<b>PROPERTY INFORMATION:</b>	<b>Bancroft Heights Preliminary</b>
<b>ADDRESS:</b>	Bancroft Chapel Rd., Kingsport, TN
<b>DISTRICT, LAND LOT:</b>	10 <sup>th</sup> Civil District, Tax Mao 032 Parcel 015.20
<b>OVERLAY DISTRICT:</b>	Not Applicable
<b>EXISTING ZONING:</b>	M1- Light Manufacturing District
<b>PROPOSED ZONING:</b>	PD – Planned Development
<b>ACRES:</b>	+/- 14.199
<b>EXISTING USE:</b>	Industrial
<b>PROPOSED USE:</b>	Residential

The applicant is requesting preliminary Planned Development plat approval for the Bancroft Heights Subdivision development, consisting of 63 single-family detached units.

**RE: Bancroft Heights Subdivision  
Bancroft Chapel Road  
Permit Application #RESDEV26-0053  
Variance Request: Sidewalk Width on Fire Apparatus Access Road Cross-Section**

Proposed Fire Apparatus Access Road:

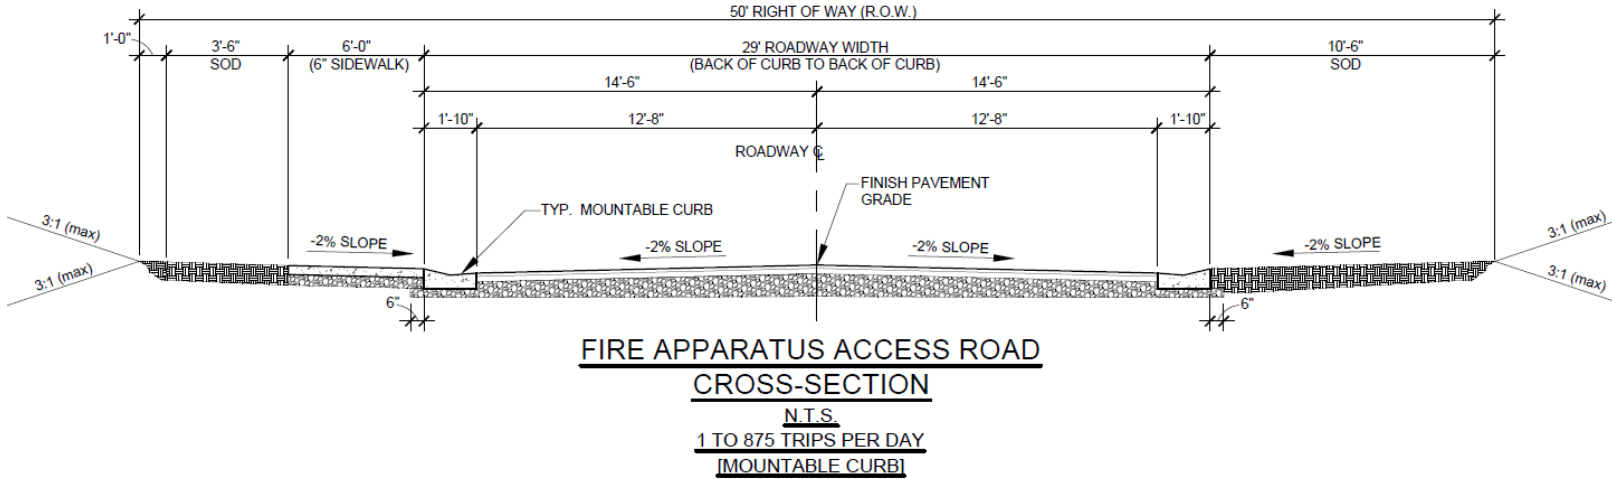
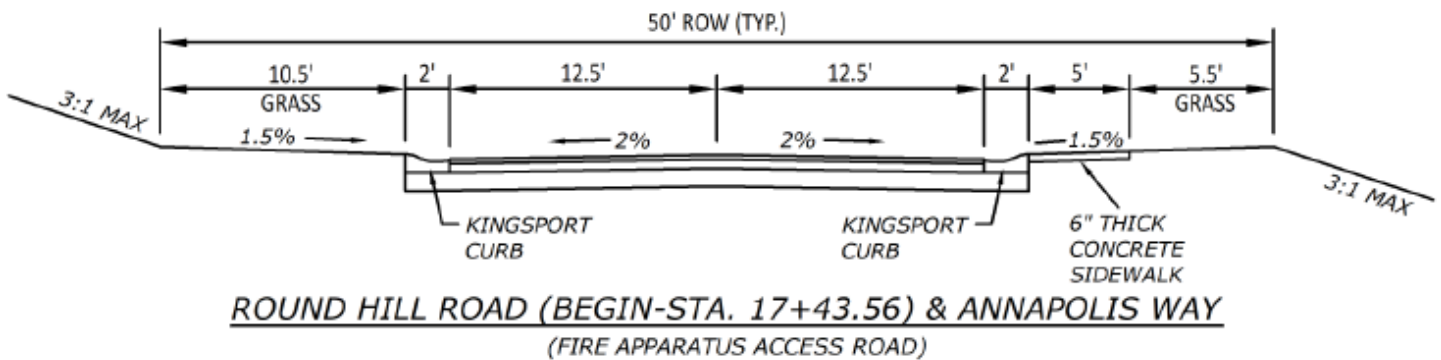
- The applicant is seeking to install a 5’ wide sidewalk instead of the minimum 6’ wide sidewalk as shown on the Fire Apparatus Access road cross-section in Appendix B of the Subdivision Regulations. The 5’ wide sidewalk is being requested from the beginning of Round Hill Road all the way to the intersection of Round Hill Road and Annapolis Way and all of Annapolis Way. By approving this request the 5’ wide sidewalk variance will be consistent with the rest of the developments 5’ wide sidewalk required by the Residential Street Cross-Section.

We are requesting the sidewalk along Round Hill Road from its beginning to Station 17+43.56 and along Annapolis Way be 5' wide instead of 6' wide as indicated on the City's Fire Apparatus Access Road cross-section. This will match the remaining sidewalk widths throughout the development, and will also be consistent with the City's standards for all other roadway cross-sections.

Therefore, Staff recommends granting preliminary plat approval, and acceptance of the variance request for the Bancroft Heights preliminary plat contingent upon the construction plans being approved.

Staff recommends granting Preliminary Plat approval, and accepting the variance request for the Bancroft Heights Preliminary Plan contingent upon the construction plans being approved.
